TECHNICAL

FACTORY DIRECTED MODIFICATION

ENG 24-01 | CODE: National | DATE: February 5, 2024

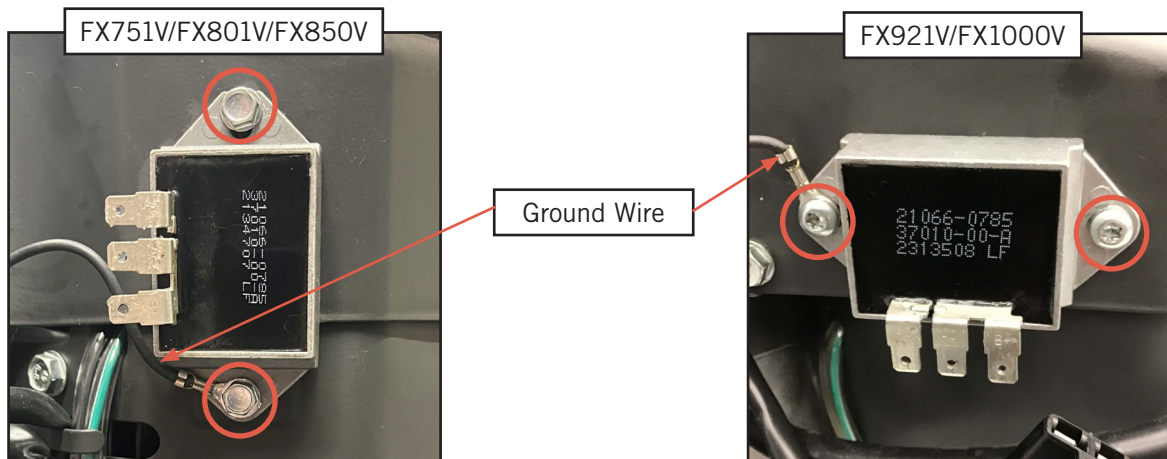
- If bar-code label does have a verification mark “●”, FDM has been completed on the engine. No further action is required.
  - If bar-code label does not have a verification mark “●”, continue to step 3.
3. Disconnect the Negative (-) battery cable.
  4. Disconnect the stator coil lead connector and B+ lead wire connector.

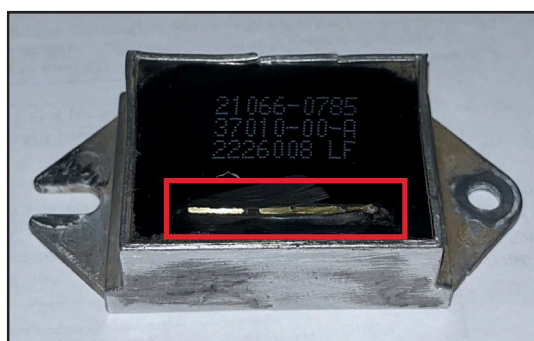
5. Remove 2 voltage regulator mounting screws and ground wire.
- FX751V/FX801V/FX850V: Discard 2 voltage regulator mounting screws.
  - FX921V/FX1000V: Retain 2 voltage regulator mounting screws.

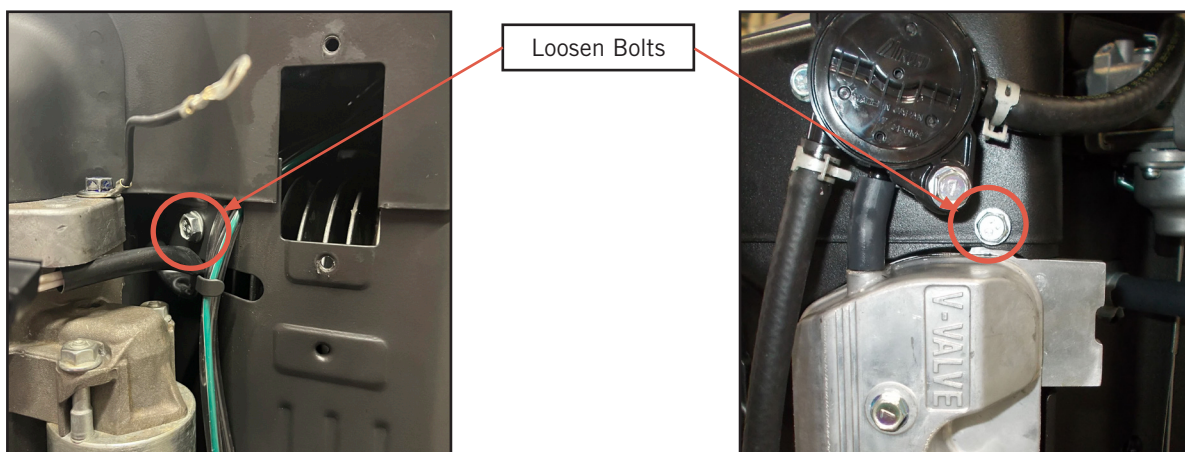
6. Cut the terminals off the 21066-0785 voltage regulator and scrap the voltage regulator.

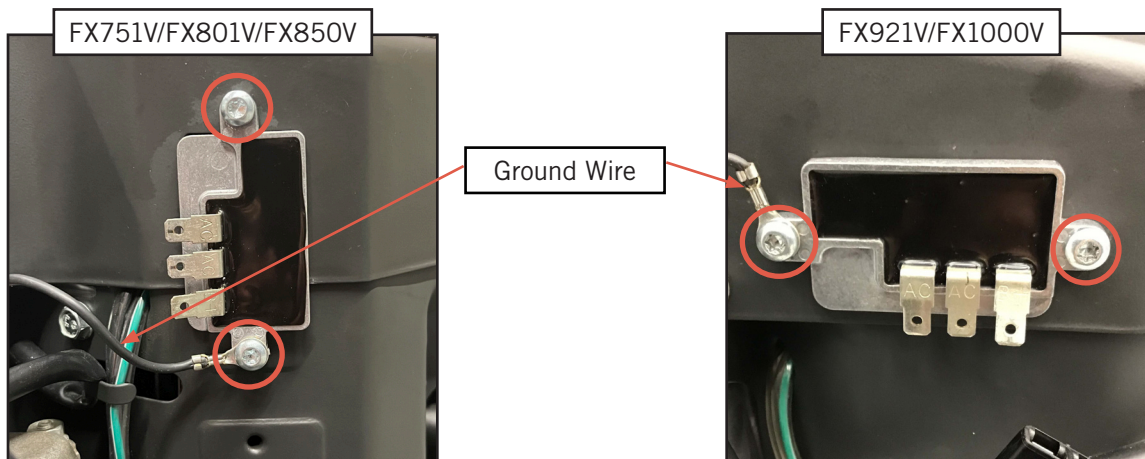
7. For FX751V/FX801V/FX850V engines, loosen (2) #1 cylinder head shroud bolts to allow for proper alignment of voltage regulator lower mounting screw. For FX921V/FX1000V engines, go to Step 8.

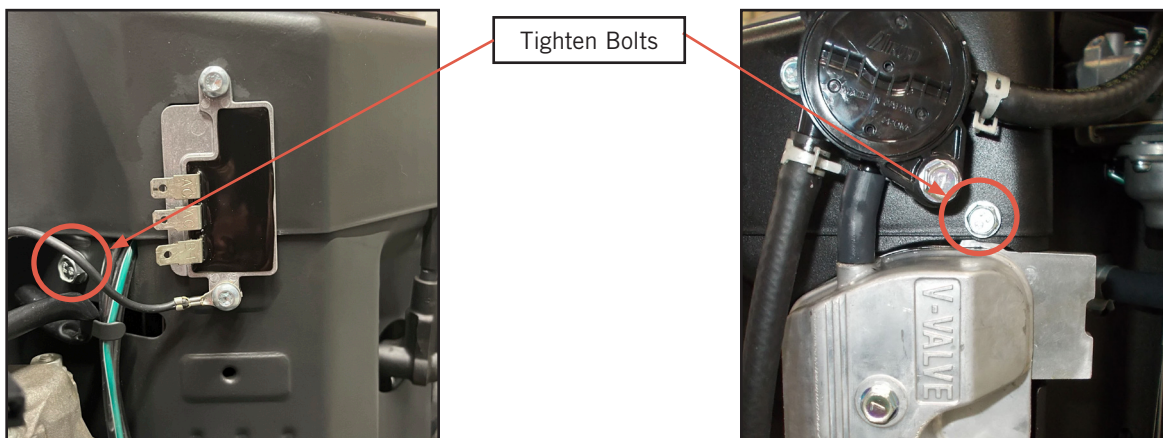
8. For FX751V/FX801V/FX850V engines, use voltage regulator 21066-7017 and (2) 92172-1091 screws from kit 99999-0934.  
For FX921V/FX1000V engines, use voltage regulator 21066-7017 and mounting screws retained in step 5.  
Install voltage regulator with ground wire. Torque voltage regulator mounting screws to 3.5 N-m (0.36 kgf-m, 31 in-lb).

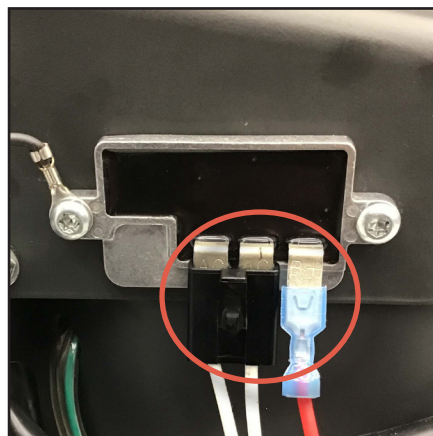
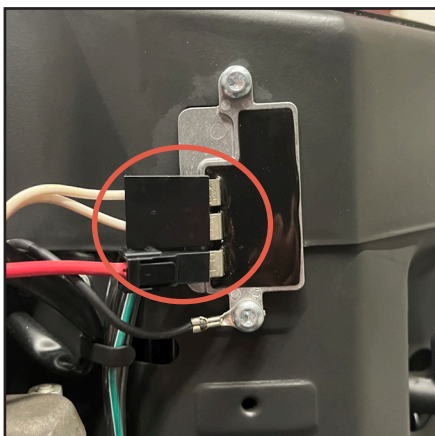
10. Apply automotive grade dielectric grease to the regulator terminals, then connect the stator coil lead connector and the B+ lead connector.

Dielectric grease must be applied to new 21066-7017 regulator terminals to ensure proper electrical contact and prevent corrosion.
